DEPARTMENT OF PROCUREMENT
BYNUM RUN INTERCEPTOR SEWER - PHASE 7
CONTRACT NO. 6703
BID NO. 15-154

ADDENDUM NO. 1

January 15, 2016

SHEET No. 5 OF 23

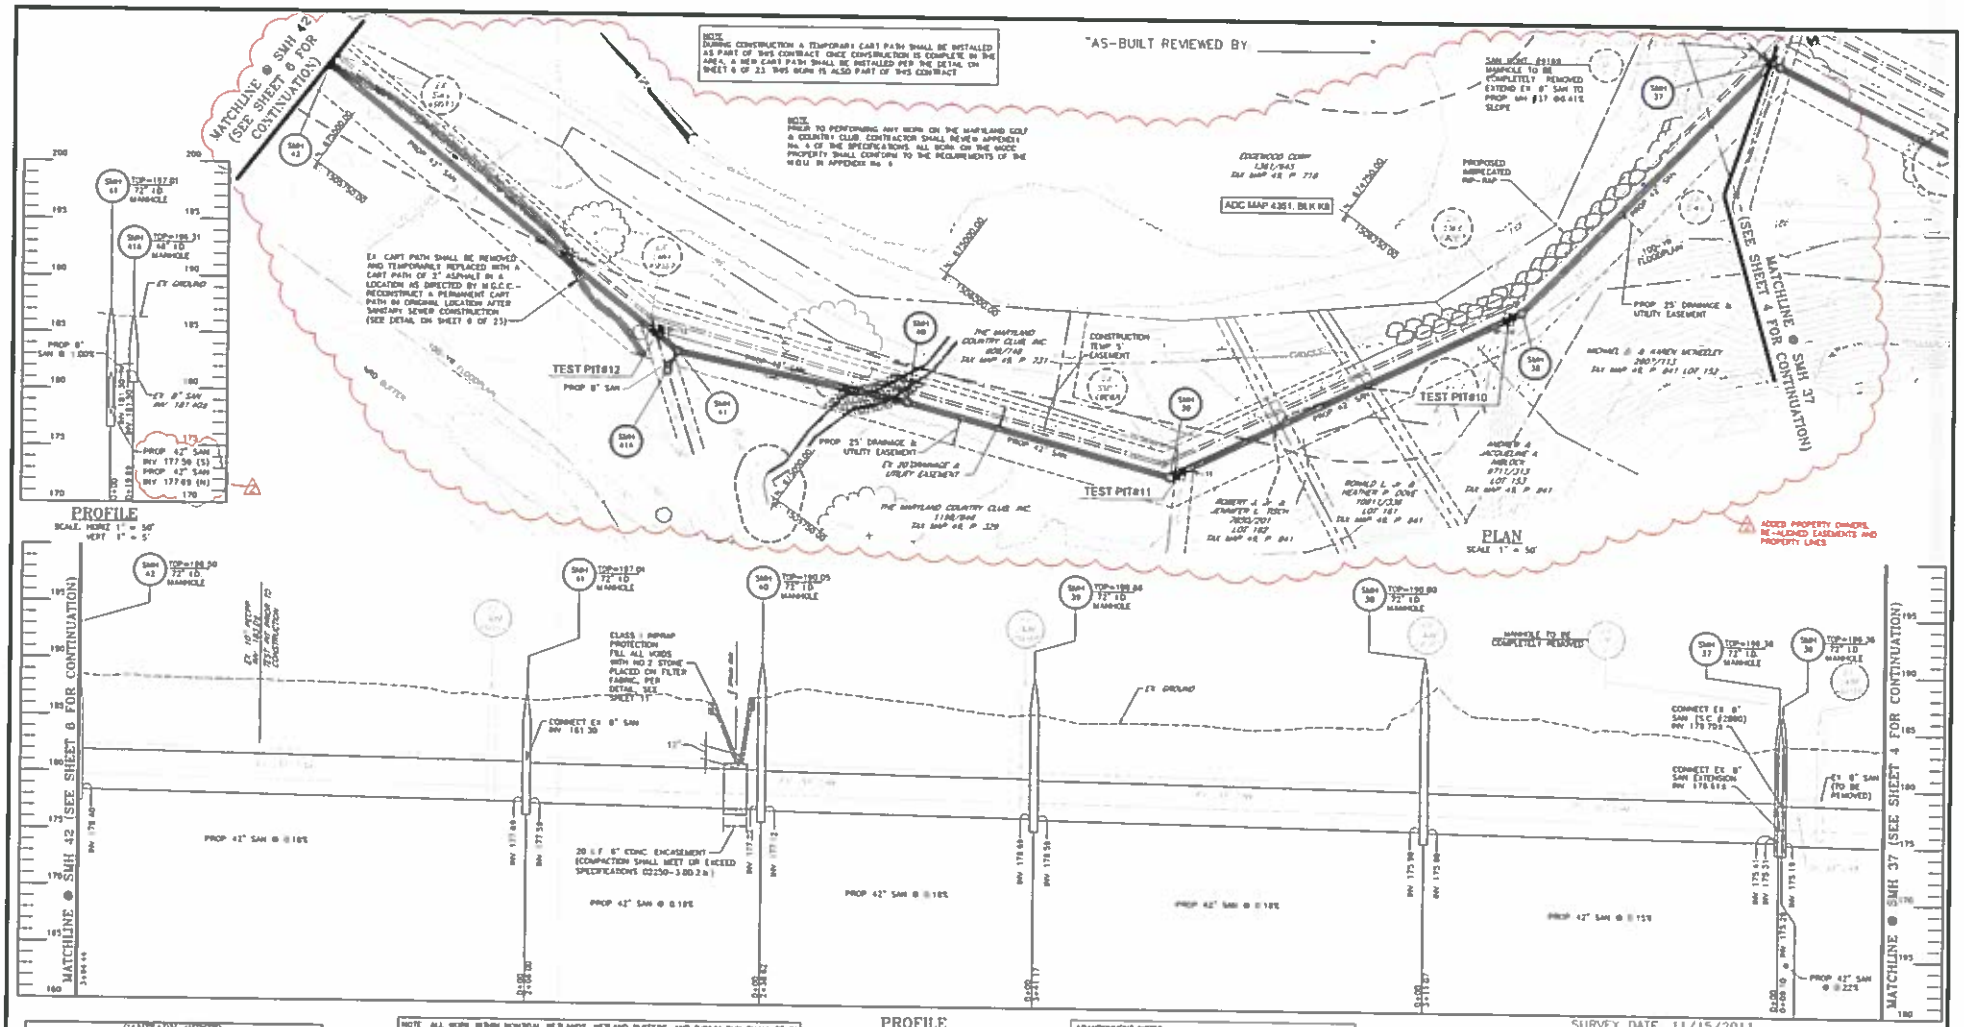
1. Replace Sheet 5 in its entirety with revised Sheet 5, revision date January 12, 2016, attached. The easement and property line locations were corrected, property owner information added and/or corrected, and invert elevation in the upper left profile corrected.

SHEET No. 8 OF 23

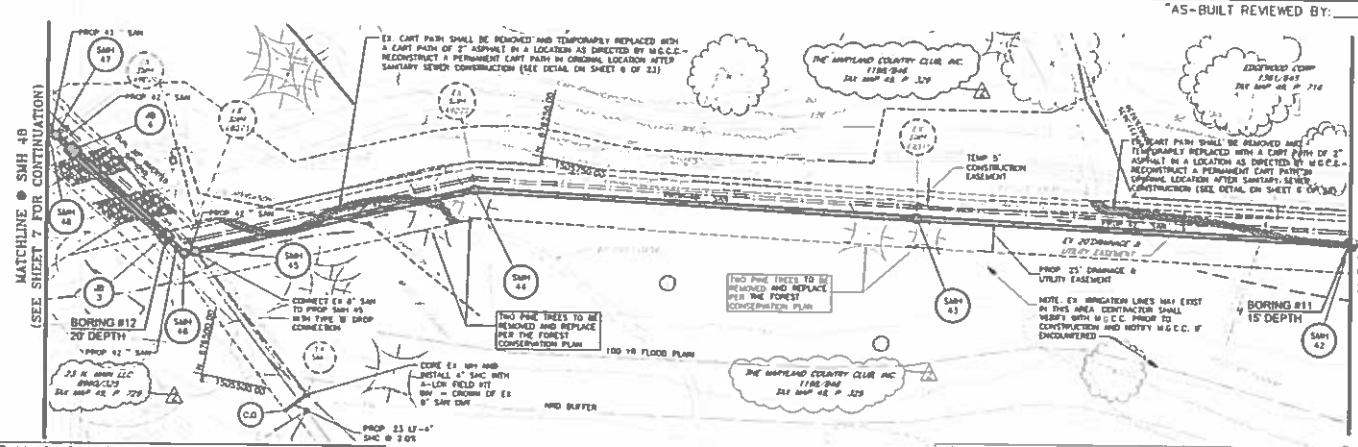
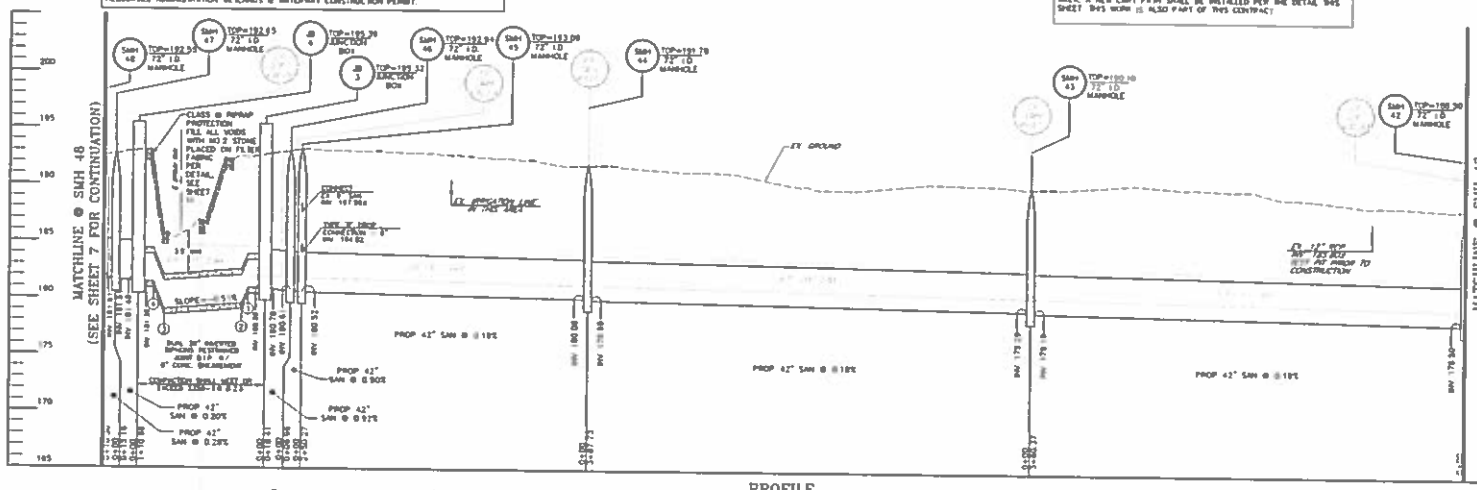
4. On Sheet 8, near SMH-60, revise the notation "Test Pit #21" to read "Test Pit #20". Also, above the notation for SMH-61, remove the complete property owner reference "John S. & Dana Gonzalez, Jr." In the jack and bore Data Table, in the Carrier Pipe column, revise the contents to be handled to "Sewage", and revise the carrier pipe material to "Ductile Iron, Class 56".
